B.G.A. TECHNICAL COMMITTEE

TECHNICAL NEWSHEET

TNS 9/10/88

Service Bulletin
TM 315-37

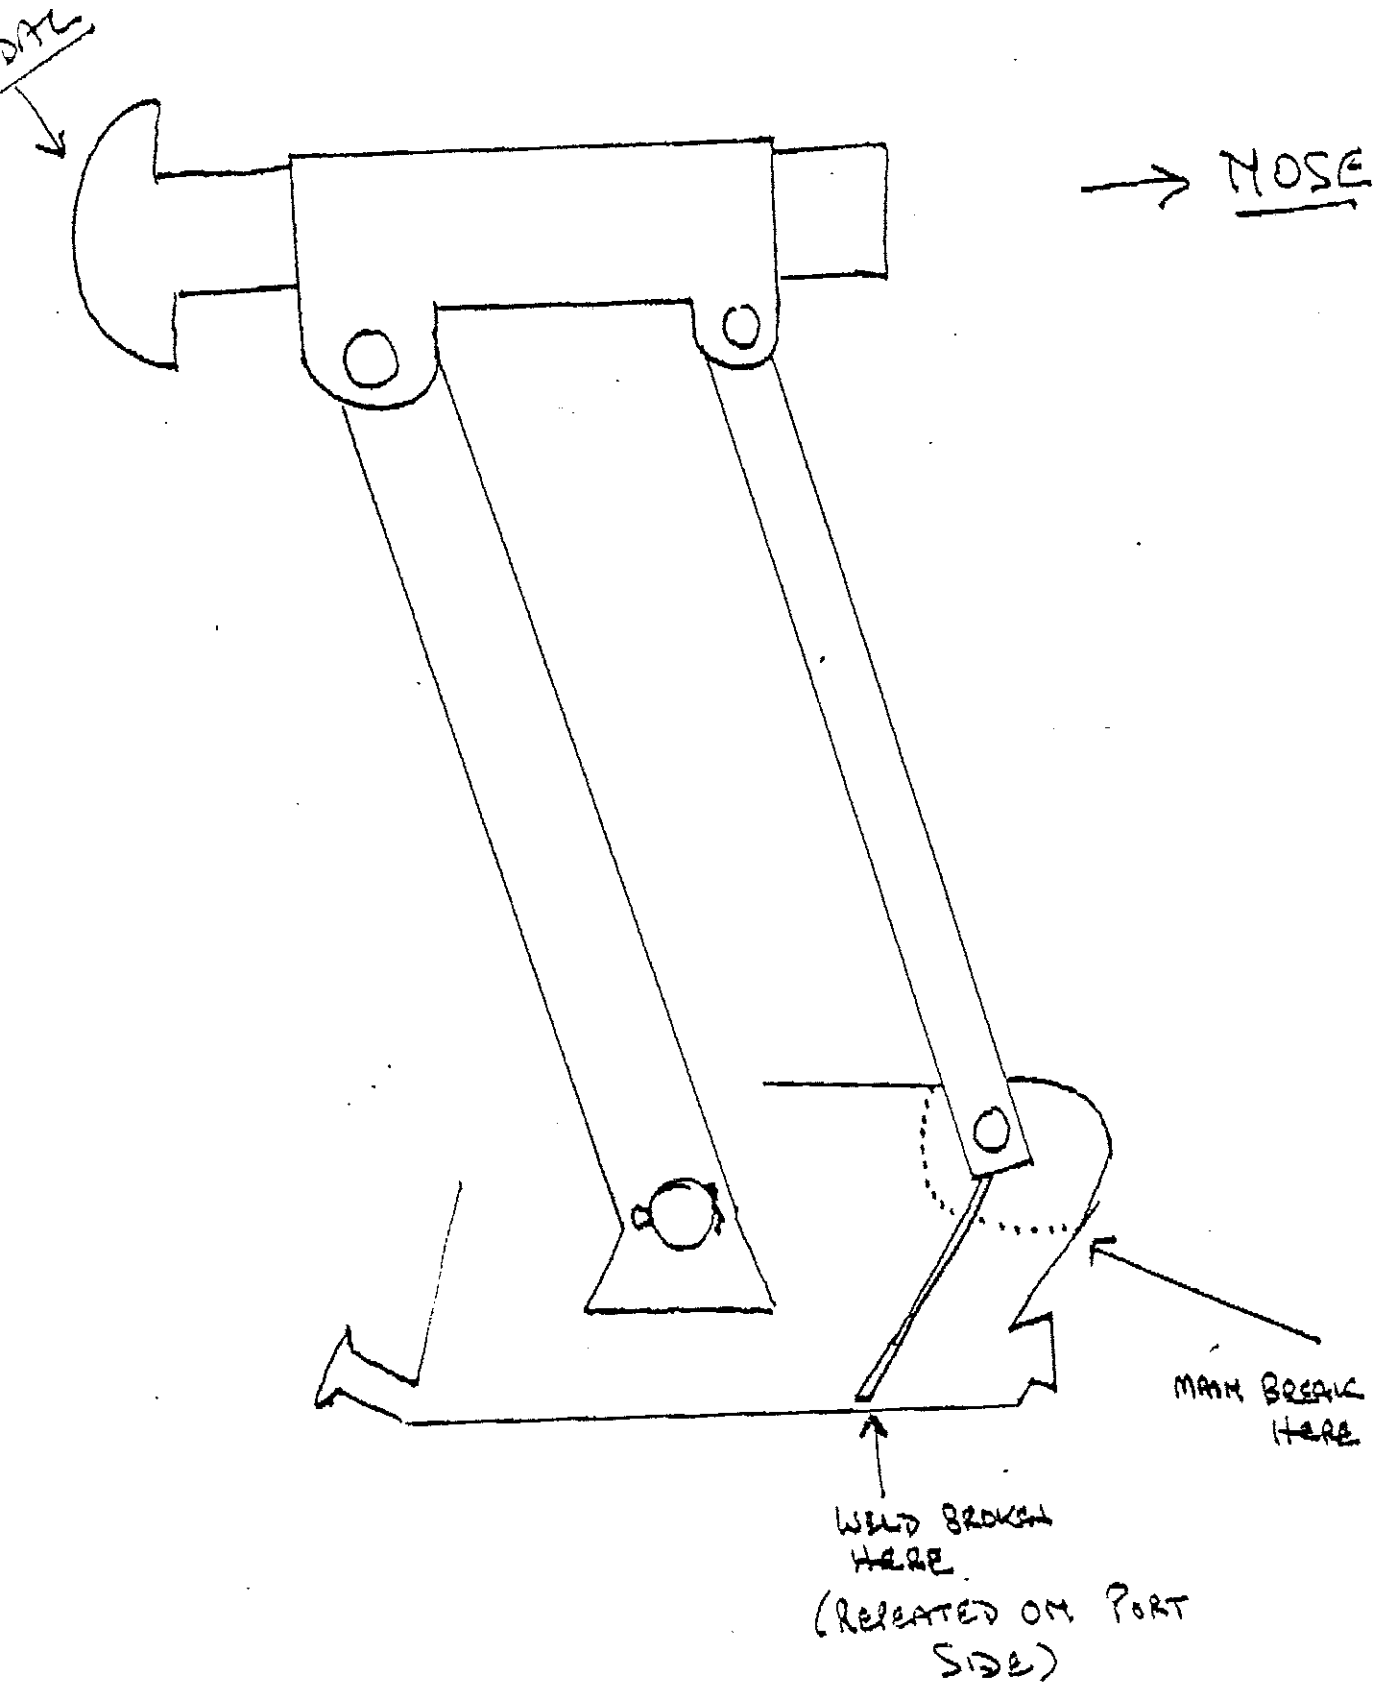
Subject: Inspection and reinforcement of welded parts in the flight control system of the gliders GROB G 103 TWIN II and G 103 A TWIN II ACRO. The following welded parts will be reinforced:

Reason: Malfunctions now and then on welded control system parts in TWIN II gliders with the above s/n were the reason for the service bulletin. First, cracks appear in the area of the welds which may lead to a failure in an advanced stage. Therefore, all endangered control system parts will be reinforced through additional gussets as a precaution.

- Instruction 1 prior to the next take-off
- Instruction 2 by 31 March 1989

SF 34 TAIL PLANE REPAIR.

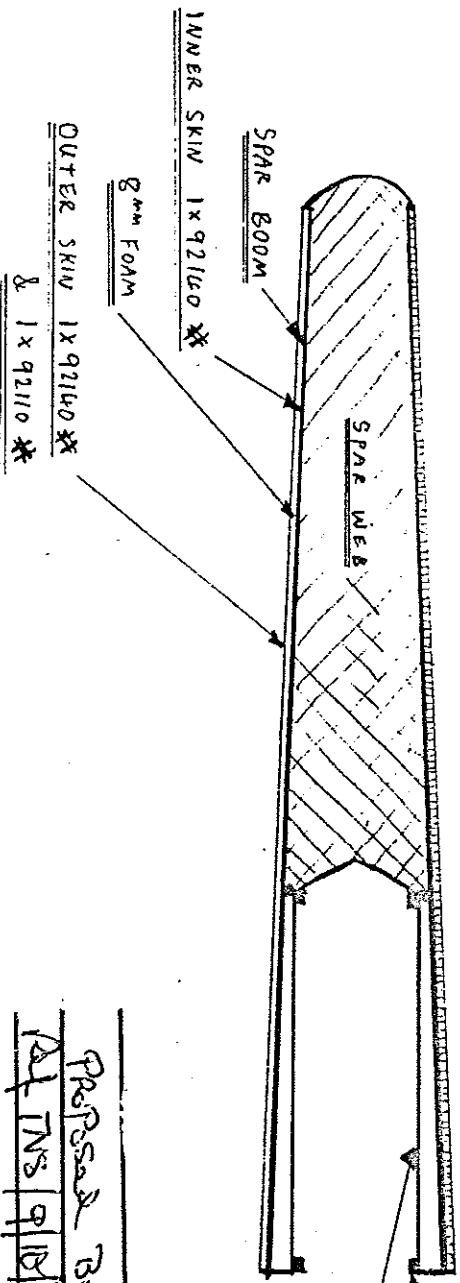
GLASS TUBE 2x921140 * GLUED TO INNER SKIN TOP & BOTTOM, BADLY BROKEN AT BOTH SIDES.

PROPOSED TO REPAIR 921140 & ADD 6x92125.

CENTRAIR 201

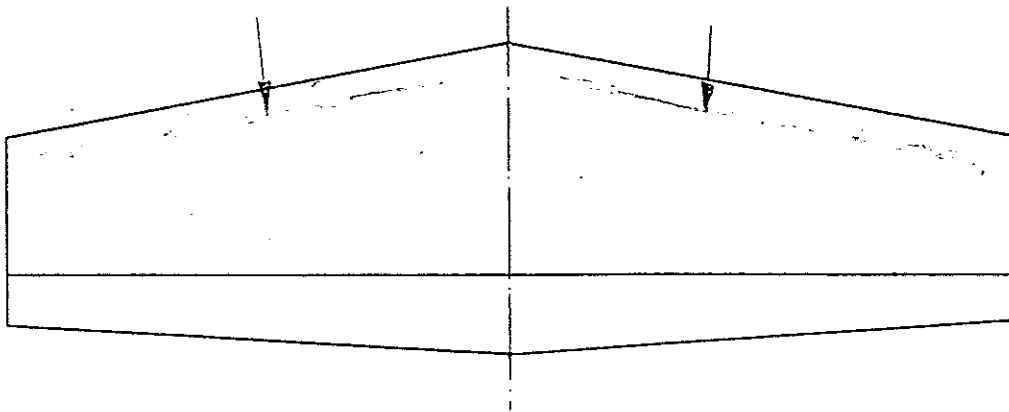
Deux cas de décollement de l'intrados du plan fixe horizontal côté droit ont été signalés. Ils peuvent avoir été provoqués par une manoeuvre malhabile.

- A) 1) Sur l'intrados du plan fixe horizontal, en particulier aux endroits définis par le croquis ci-dessous, vérifier l'absence de décollement tissus (voir manuel d'entretien page 5.11. bis).

B) Introduire dans le programme d'entretien la révision ci-jointe : p. 5.4, 5.4 Bis, 5.11, 5.11 Bis rév. 5 du manuel d'entretien.

G-AZXE LEFT
WING FAILURE

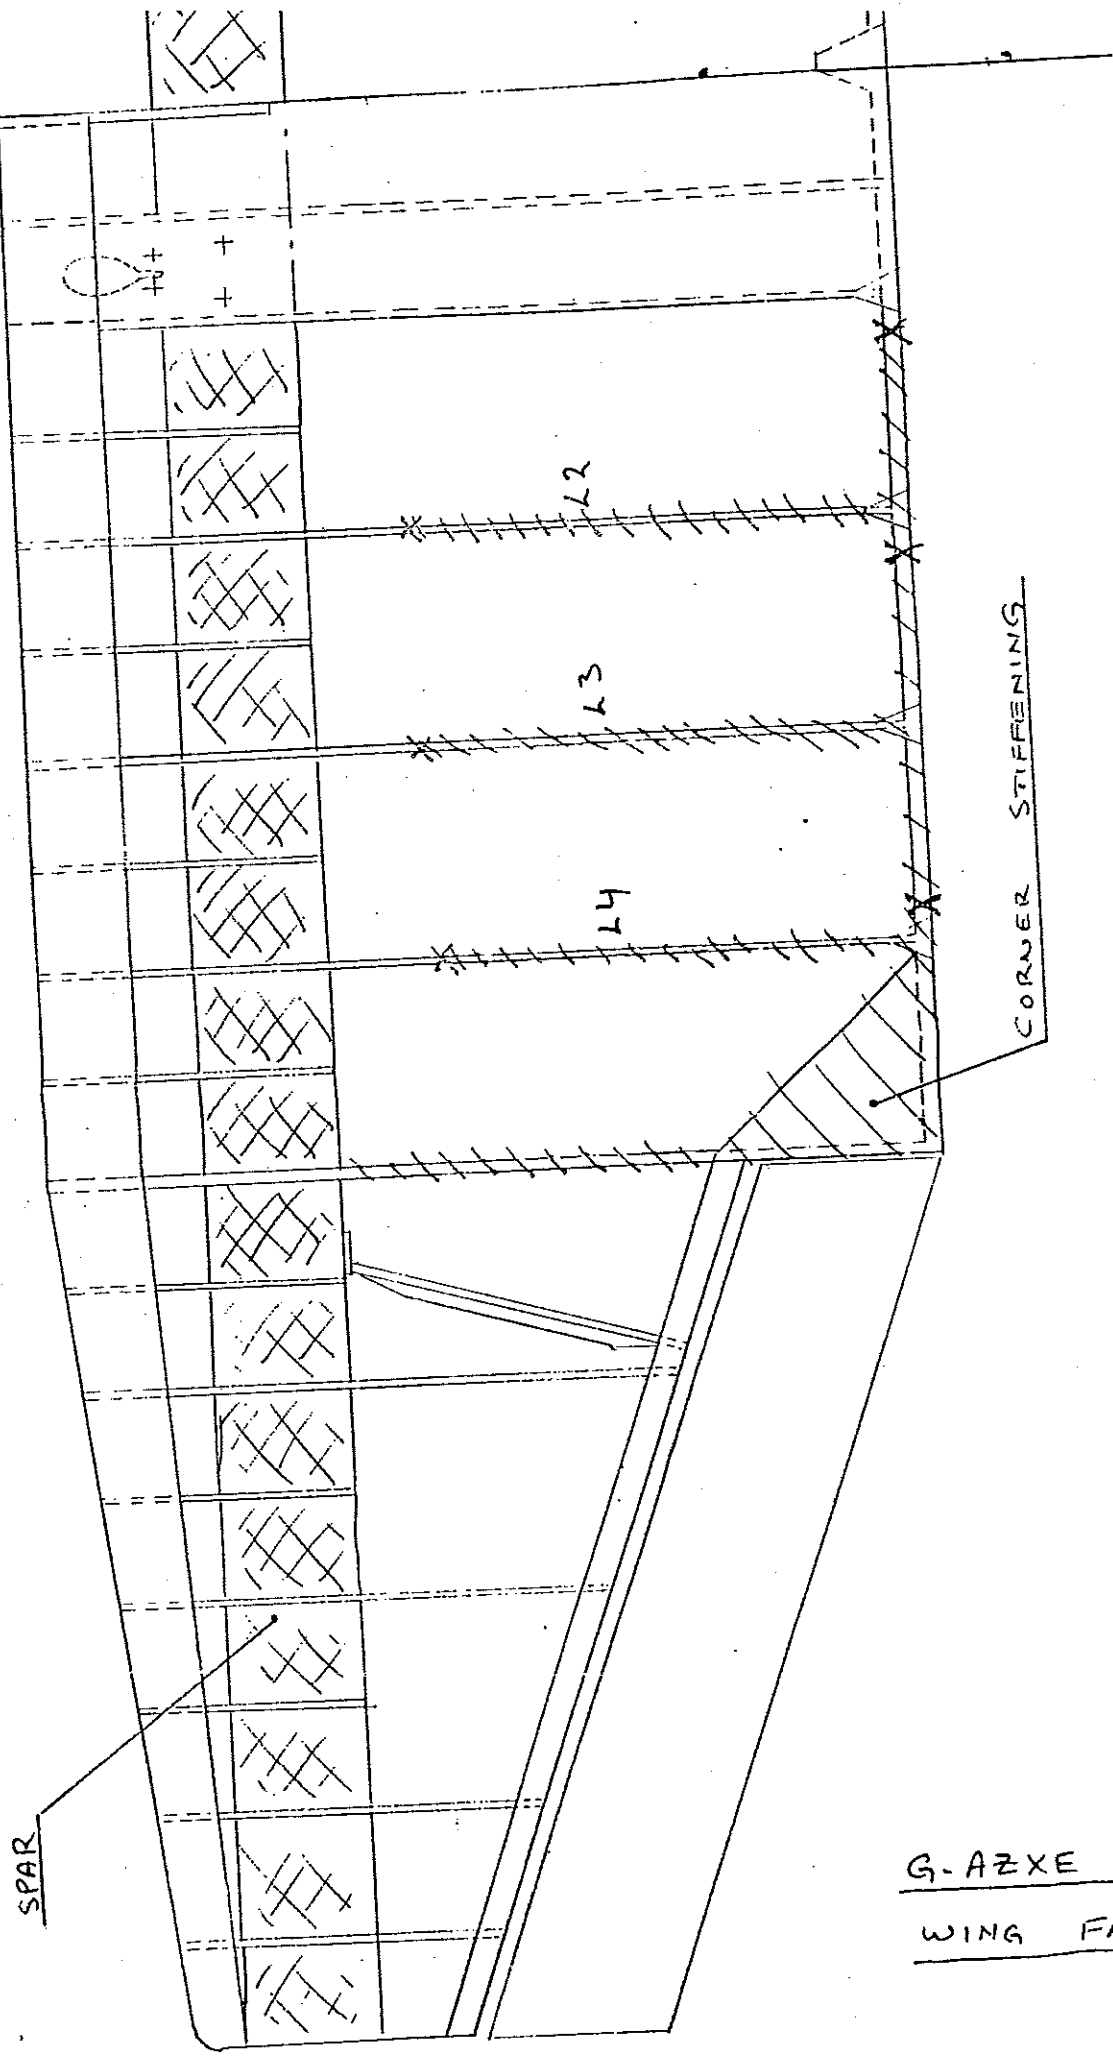
A reconstruction of the left and right wings showed the right wing to have been intact prior to impact, whilst the left wing showed evidence of failures having occurred in the centre wing rib structures, aft of the spar, and their associated trailing edge section (see figure 1). The spar itself had been intact at impact. The upper surface fabric covering this left wing had become detached in flight from the structure around all of the trailing edge. In addition, an area of lower surface fabric had also become detached at the trailing edge around the centre of this inner wing. Only some of the fabric and trailing edge section from this region of the wing was recovered from the wreckage trail.

/// = WING STRUCTURE FAILED IN FLIGHT.

KA7 - KA13. SPEED-BRAKE LEVER. (3)

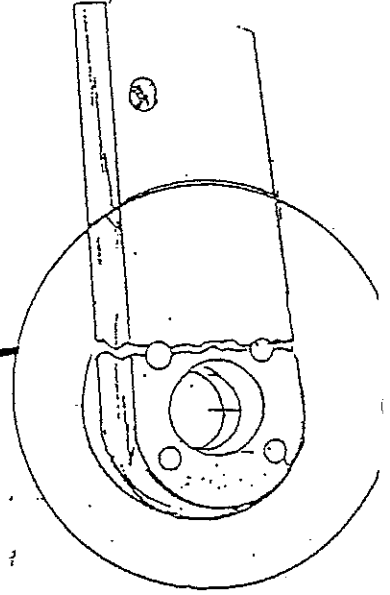
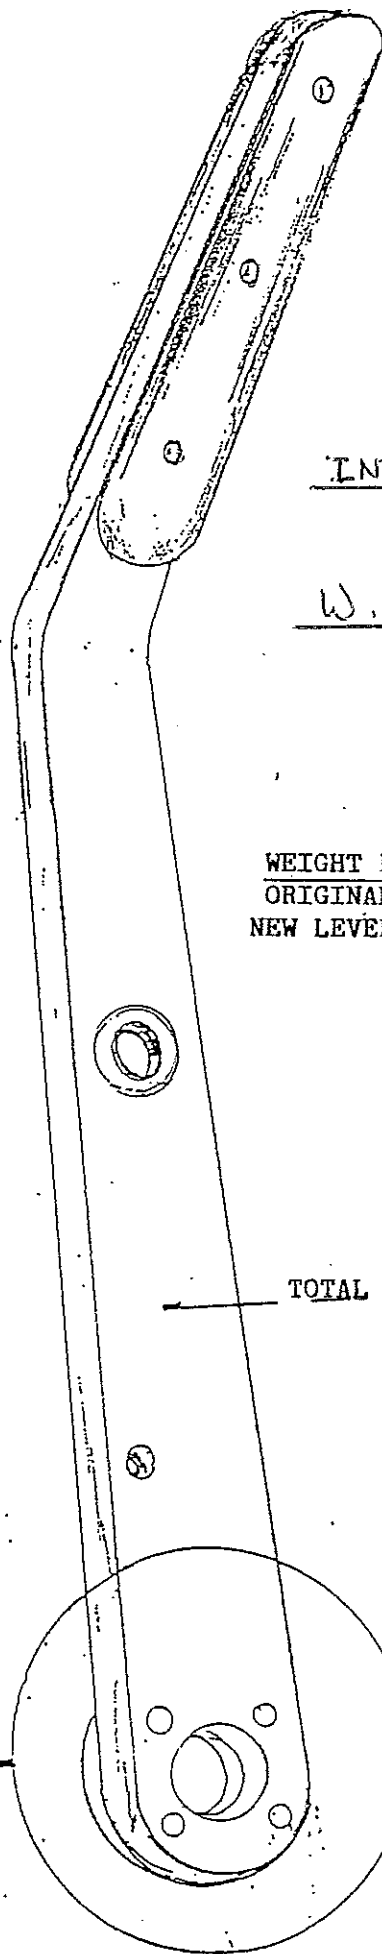
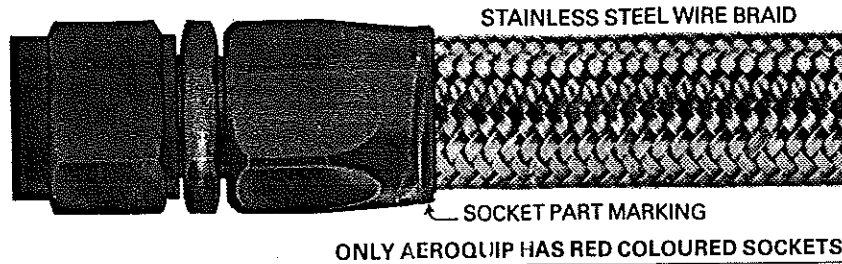
IN FLIGHT FAILURE.

FRACTURE

DIMENSIONS AS
ORIGINAL.

WEIGHT DIFFERENCE	
ORIGINAL	129.5 gm
NEW LEVER	286.0 "
	<u>156.5 "</u>
